**The W Nursing School
Neshoba General
Philadelphia, MS**

Addendum No. 6

June 19, 2026

This addendum forms a part of the contract documents and modifies the original plans and specifications dated June 4, 2026.

5
S201 3/4" = 1'-0"

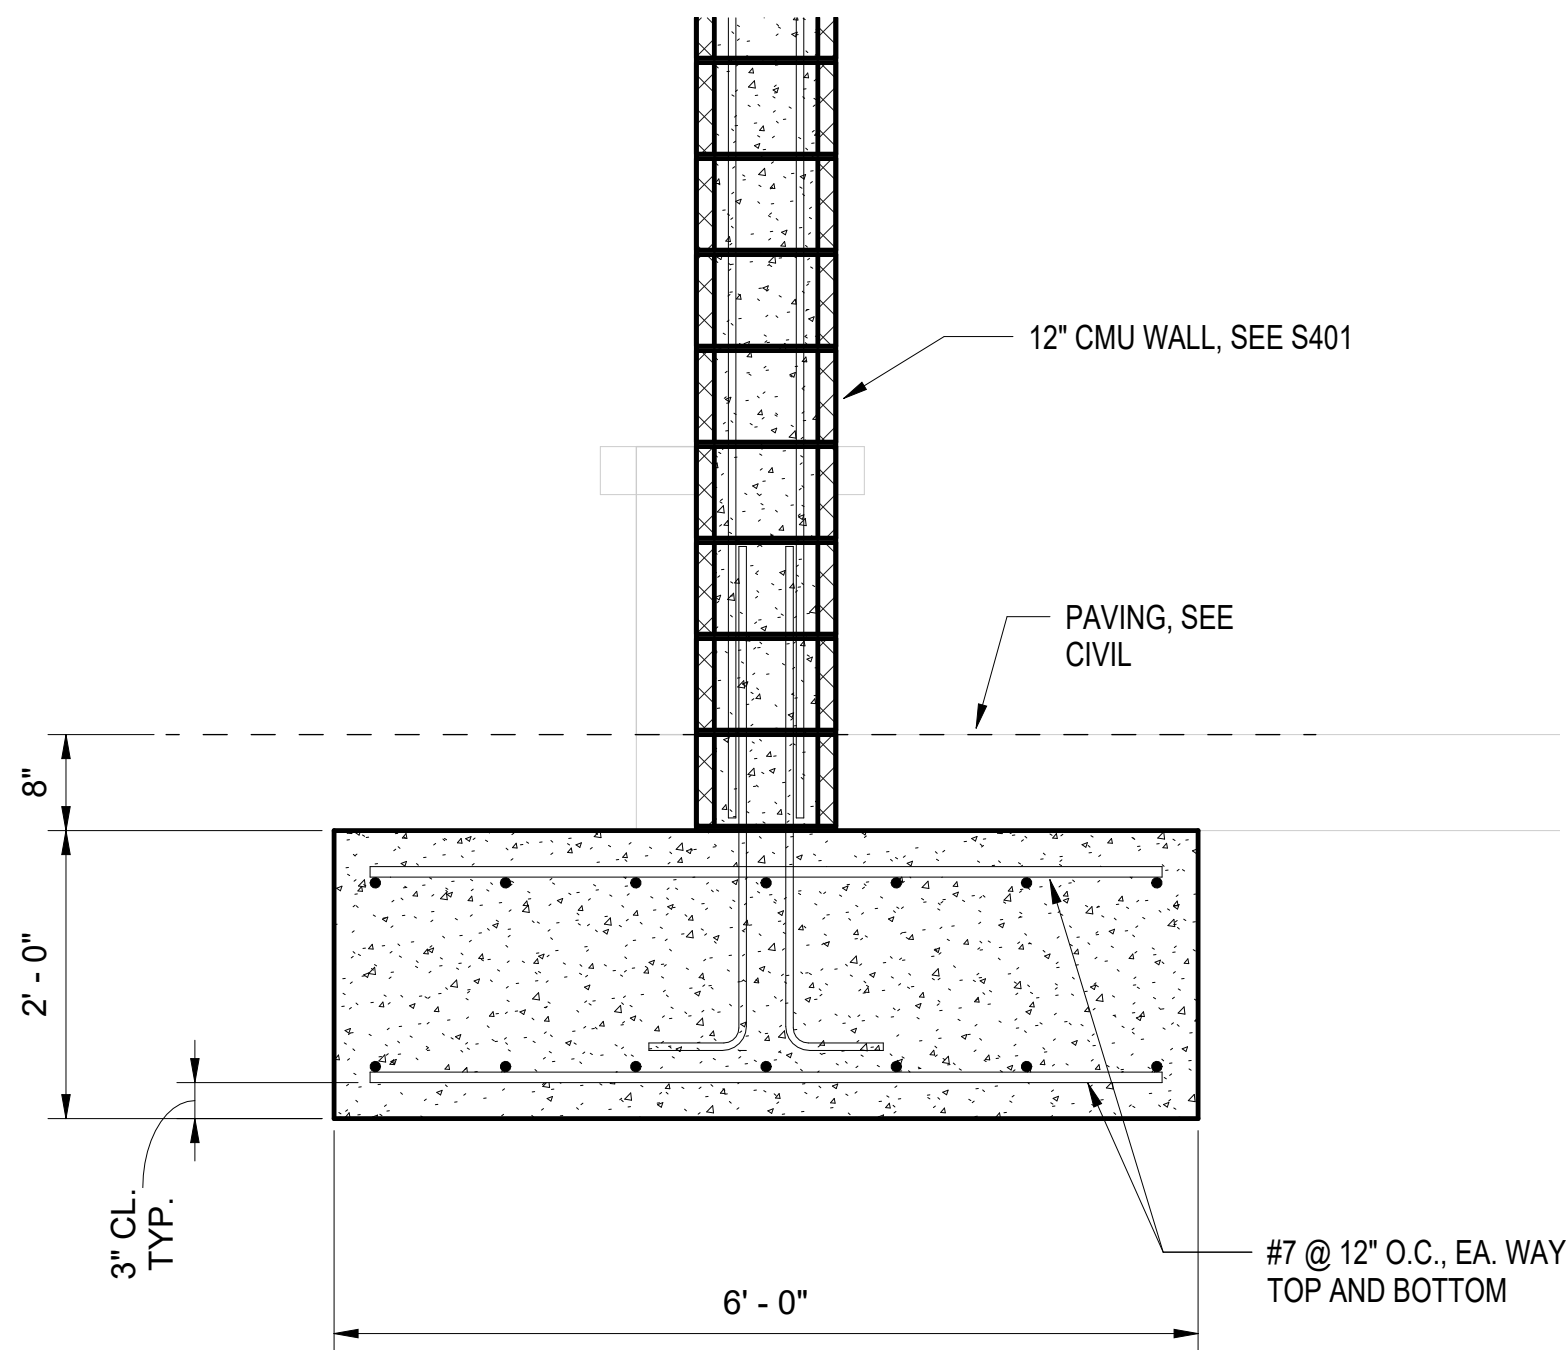
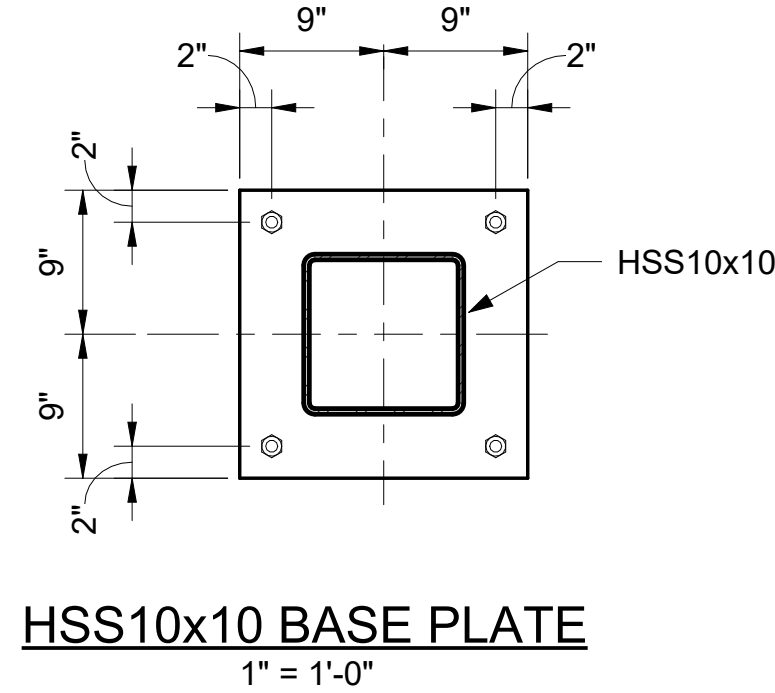
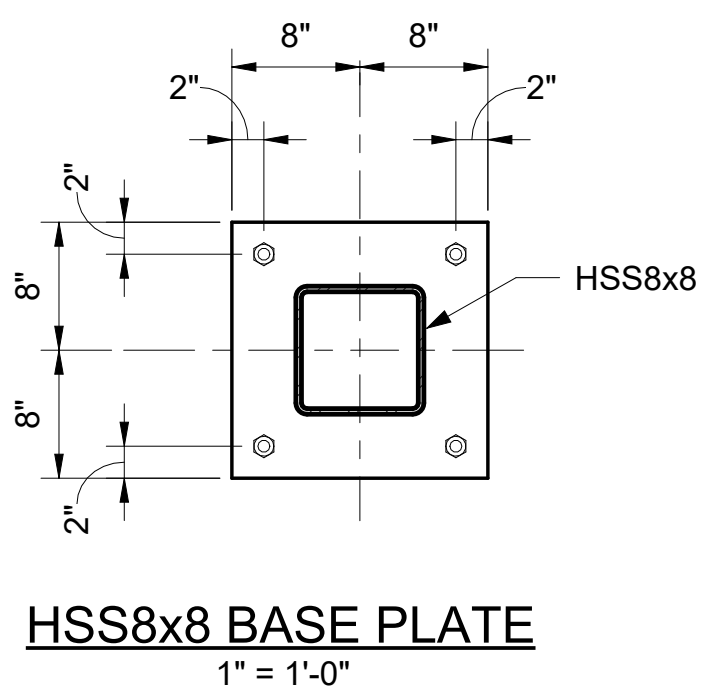
Item 6.9: Sheets S201 and S401

Note: Provide a 1'-4" screen wall at 5/S201 with 12" CMU and 4" face brick on the east face and painted CMU on the west face.
